Re: Docket No. 3B - The United Illuminating Company Amended Certificate of Environmental Compatibility and Public Need for Replacement of a Portion of the Existing Derby – Shelton 115-kV Electric Transmission Line Facility

Enclosed for filing with the Connecticut Siting Council (“Council”) are The United Illuminating Company’s responses to the Siting Council’s interrogatories dated July 5, 2022 (“Set 1”).

The United Illuminating Company
Docket No. 3B

Below is a plan view of the described modifications at Derby Junction.

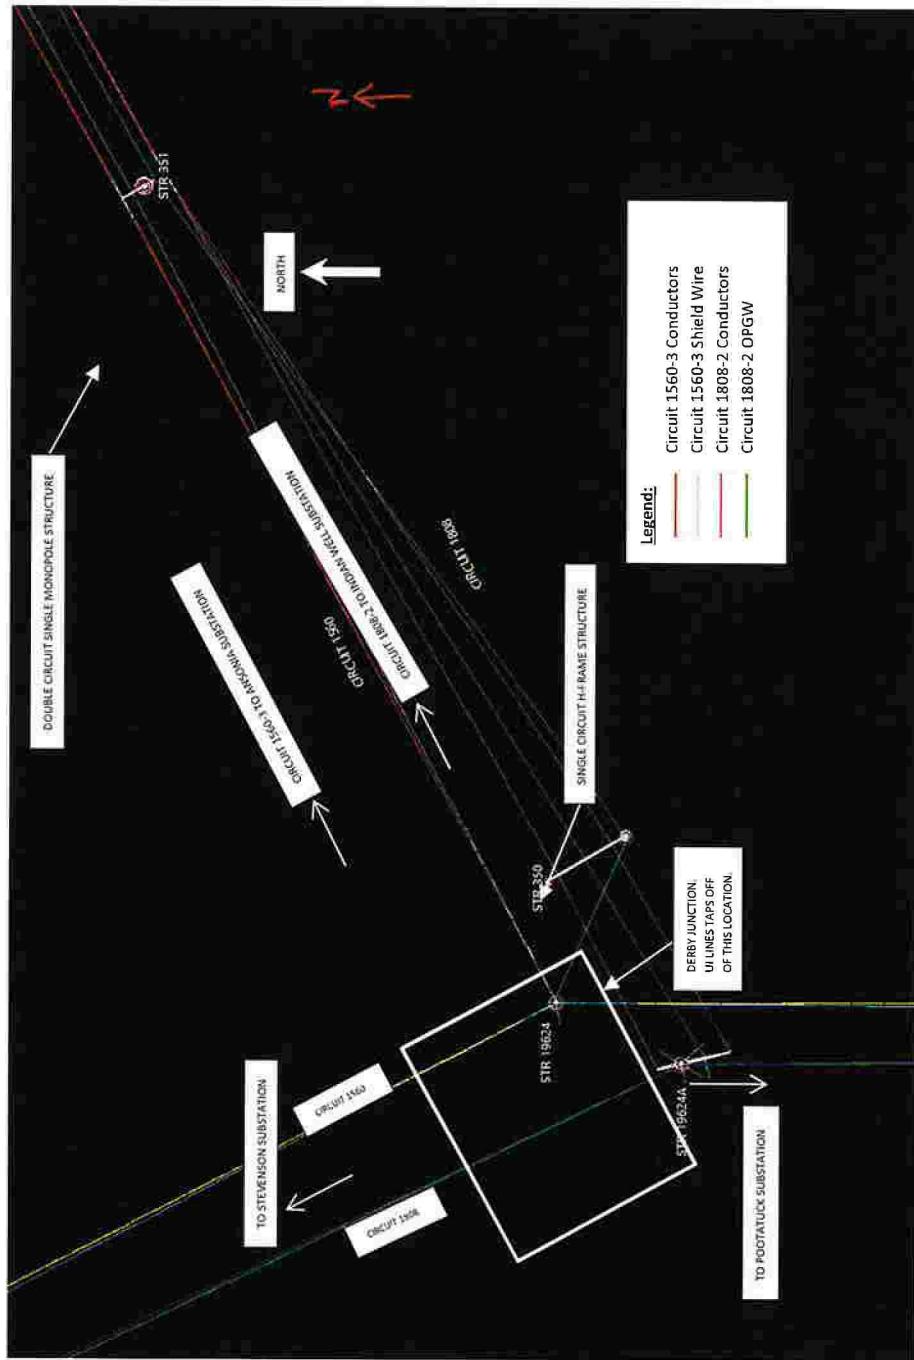
Q-CSC 1-4: What modifications, if any, are necessary at Derby Junction to connect the UI circuits to Eversource-owned and operated facilities? Referencing page 3-12 of the OS prm, what is the status of collaboration with Eversource for the tie-in?

A-CSC 1-4: UI is aware of Eversource's intention to rebuild its Stevenson to Pootatuck transmission lines (the 115-kilovolt 1560, 1808, and 1580 lines*), including at Derby Junction. Eversource's plans are described in Petition 1527. In addition, UI and Eversource have been holding monthly coordination meetings to discuss the projects. At these meetings, the two companies' representatives discuss engineering, construction, and any challenges with respect to the proposed designs.

UI understands that, as part of the Stevenson to Pootatuck work, Eversource plans to replace the existing Derby Junction tower (Structure 1364, which is current in a double circuit configuration) with a two-pole structure. The two new monopoles will be re-named as Structure 19624, which will support the 1560 Line, and Structure 19624A, which will carry the 1808 Line.

For the Project, UI will tap its 1560-3 circuit from Eversource Structure 19624 to the north side of UI Structure 351, which will be a double circuit single monopole configuration.

Similarly, UI's 1808-2 circuit will be tapped from Eversource Structure 19624A to UI Structure 350, which will be a single circuit H-frame structure with phases attached in a horizontal configuration. A horizontal configuration for Structure 350 will be required because the 1808 circuit will be cross underneath the 1560 circuit.

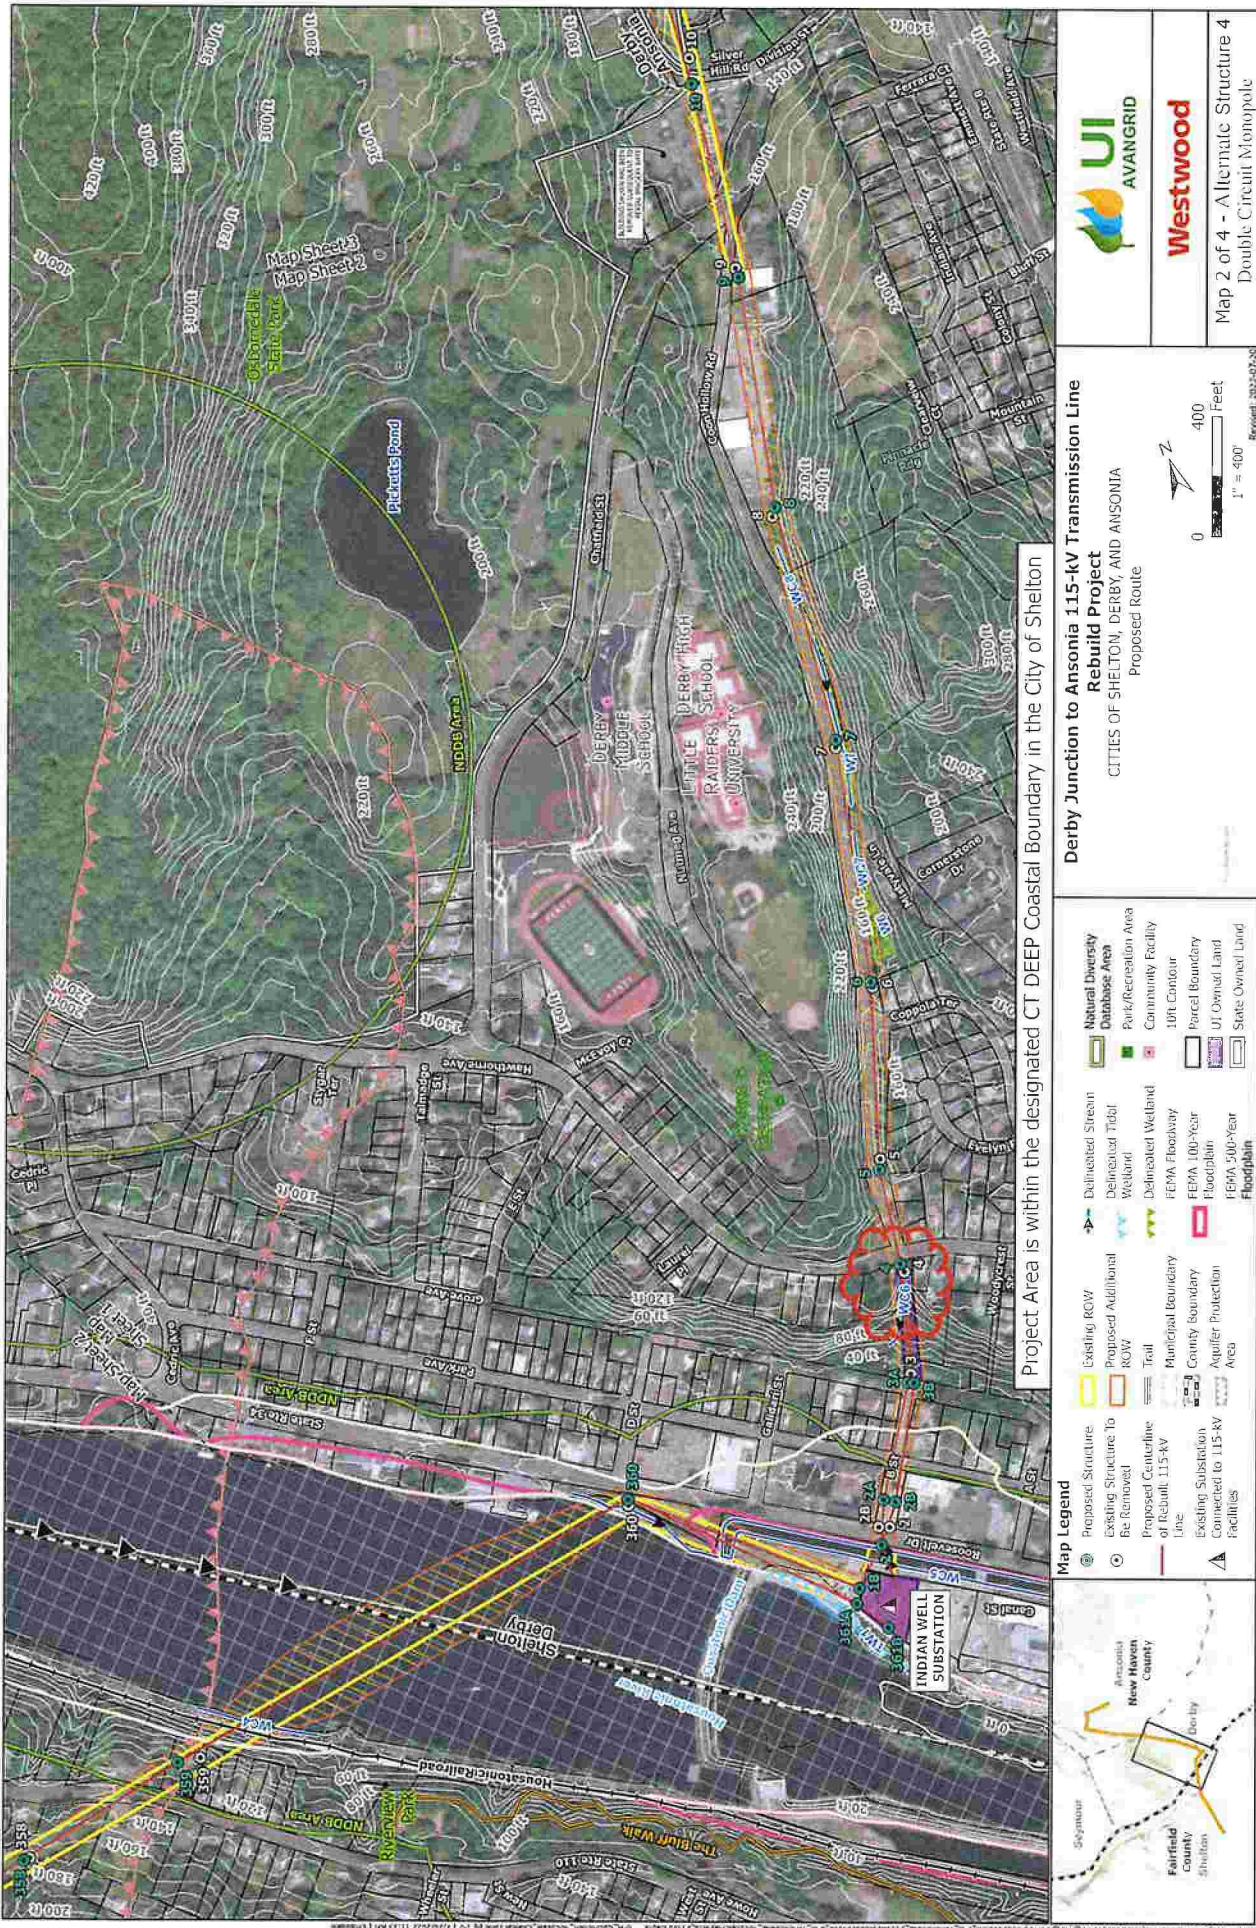
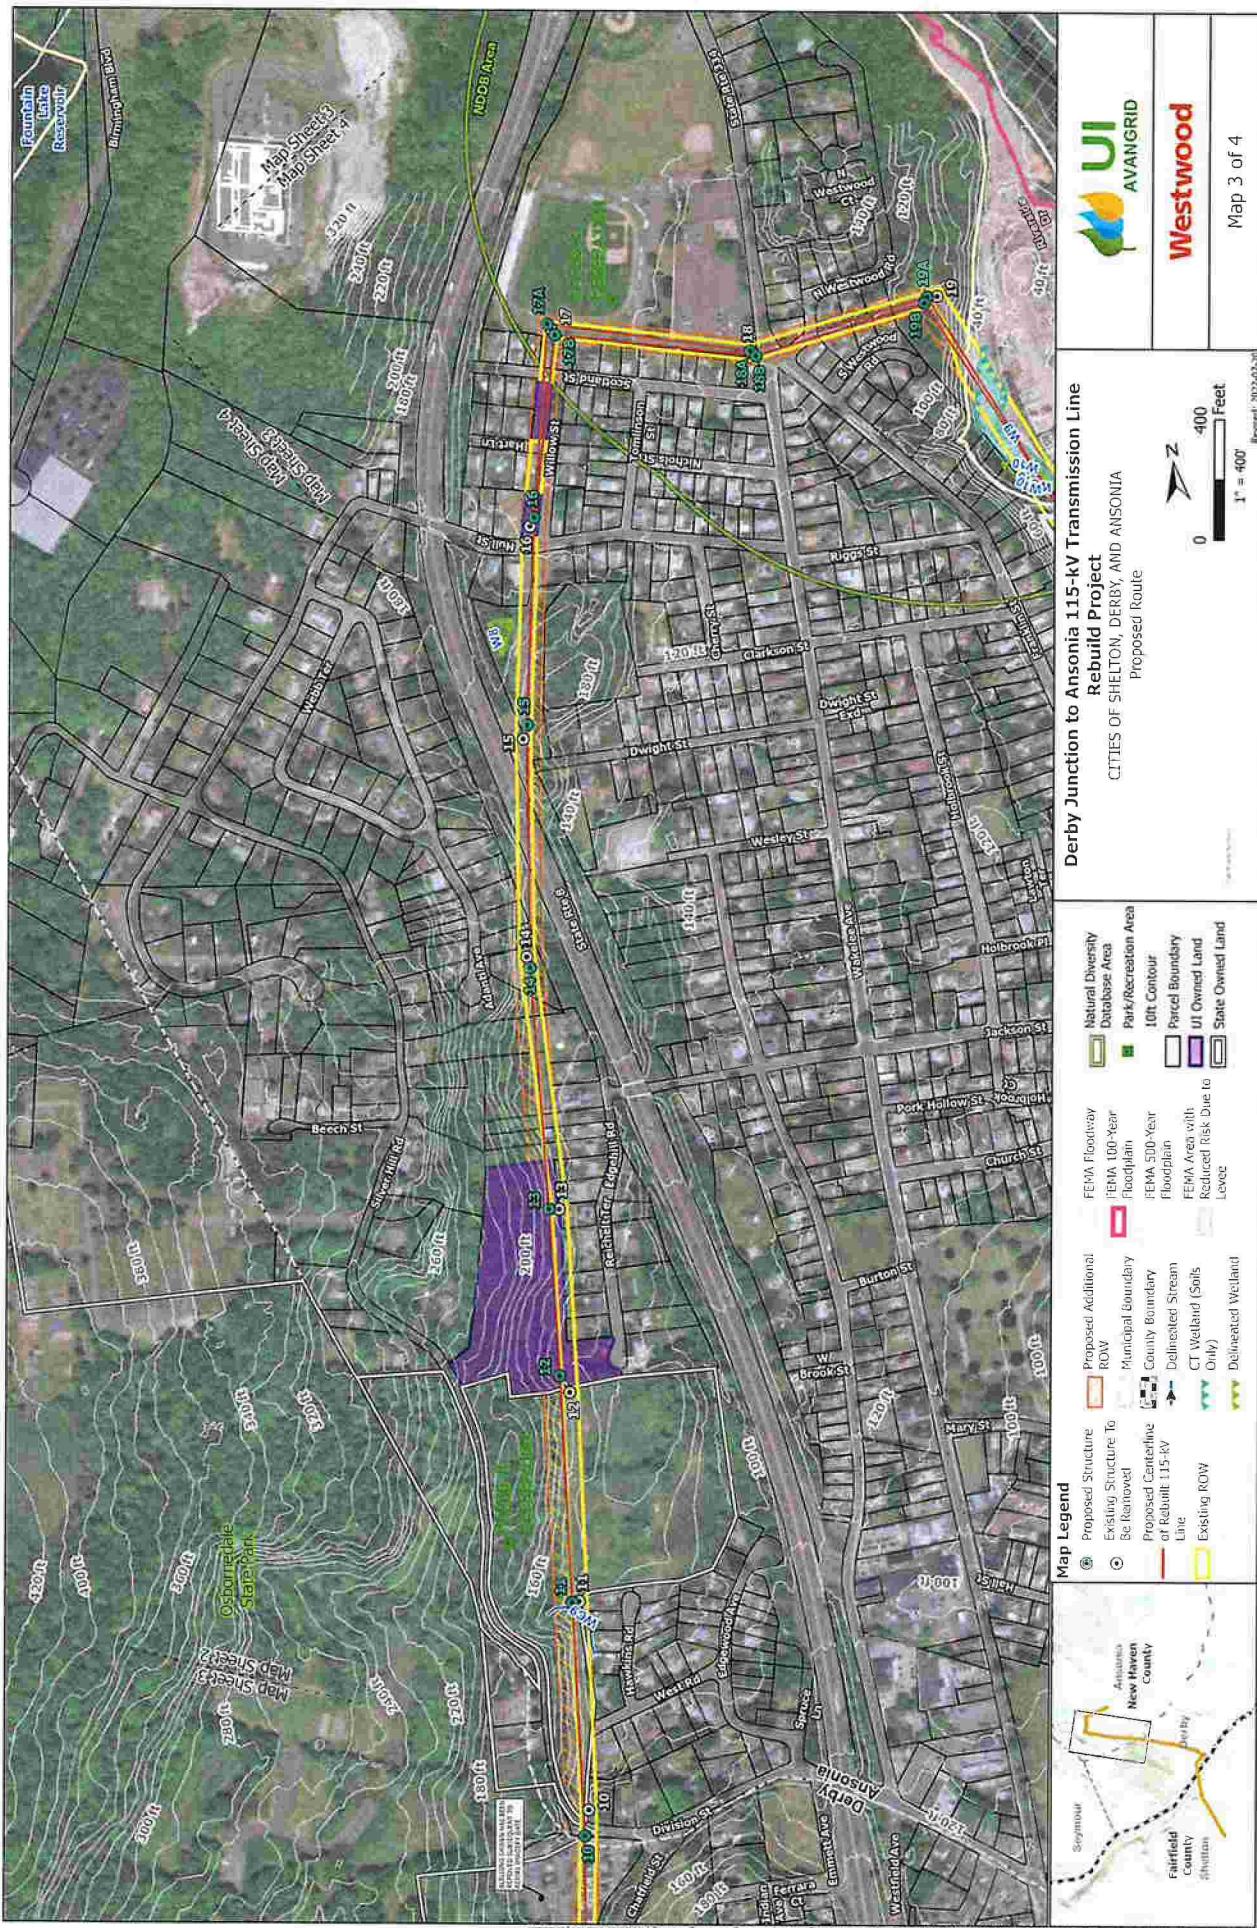
Q-CSC 1-15: Referencing page 9-22 of the OS prm, what is the status of the analysis for the use of temporary structures? What is the cost to use temporary structures?

configuration. No temporary poles will be required because this Structure was able to be placed west of the existing lattice tower, which also shifted the wires west but did not place the wires directly over adjacent buildings. This shifted location will not impact the construction sequence or overall timeline, so it will be incorporated into the preferred Project design.

The revised 1"=400' (Attachment A) and 1"=100' aerial maps (Attachment B) are to replace existing maps as follows:

- 1"=400' Scale Map 2 (Attachment A) is to replace Map 2 in Appendix A.3 of the OS prm.
- 1"=400' Scale Map 3 (Attachment A) is to replace Map 3 in Appendix A.3 of the OS prm
- 1"=100' Scale Map 7 (Attachment B) is to replace Map 7 in Appendix A.4 of the OS prm
- 1"=100' Scale Map 8 (Attachment B) is to replace Map 8 in the Appendix A.4 of the OS prm
- 1"=100' Scale Maps 11 and 12 and the associated owner/direct abutter lists (Attachment C) are to replace Maps 11 and 12 and Owner lists in Appendix A.4 of the OS prm
